UNITED STATES PATENT AND TRADEMARK OFFICE

APPLICATION NO.	FILING DATE	FIRST NAMED INVENTOR	ATTORNEY DOCKET NO.	CONFIRMATION NO.
10/540,714	09/02/2005	David Dreher	05-377	2413

Office Action Summary

DETAILED ACTION

attachment # 1
(12/28/2006)

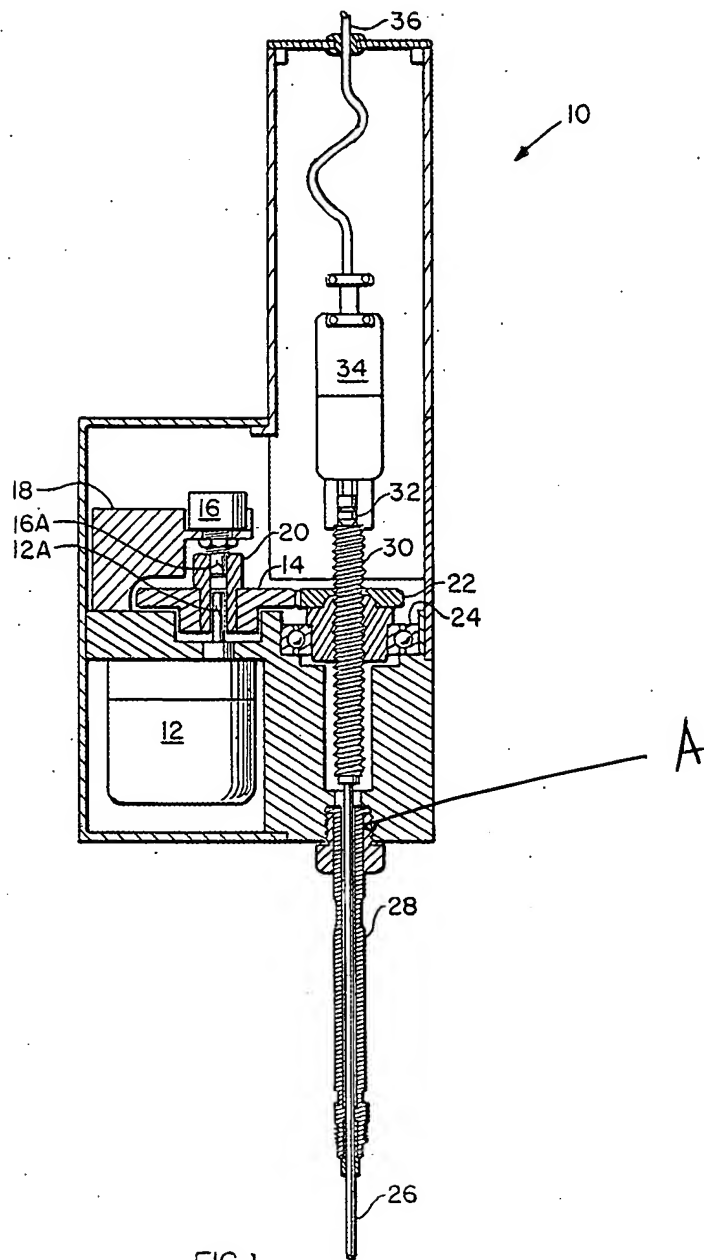
Fox discloses a device in the field of applicant's endeavor comprising extraction threads A adjacent to a crimping sleeve 28. (the numeral A has been added by the Examiner, see attachment # 1 to the Office action).
